**SUBJECT:**  
**TX28 X3 FLASH UPDATES - REVISED**

**TECHNICAL BULLETIN: 18-16**  
**DATE: DECEMBER 20, 2018**

**CRITICAL UPDATE – X3 FLASH UPDATE REQUIRED FOR TX28**  
**(ARGO 7, ARGO 12, OR RL2/RL5/FT5/RT2) X3 ATMS**

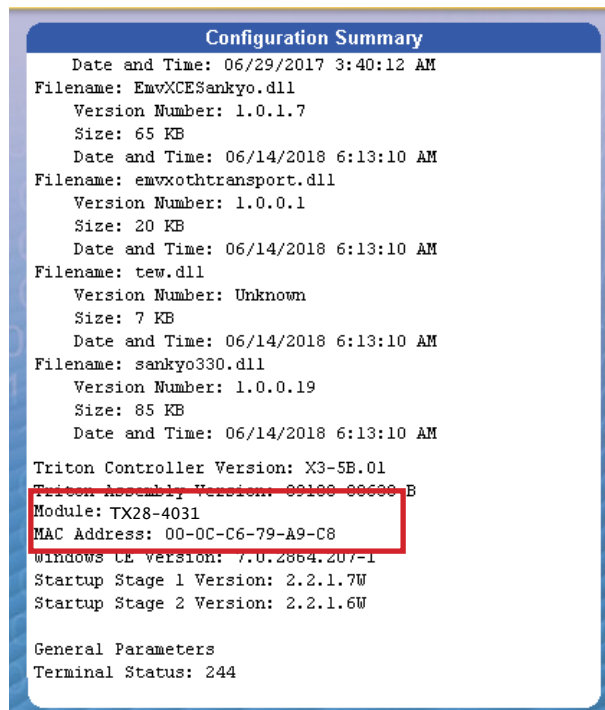
To verify the main board module model, navigate to *Management Functions > Diagnostics > Terminal Status > Configuration Summary*.

Page down to the end of the filename list to find the module model. The MAC address is listed directly below module model.
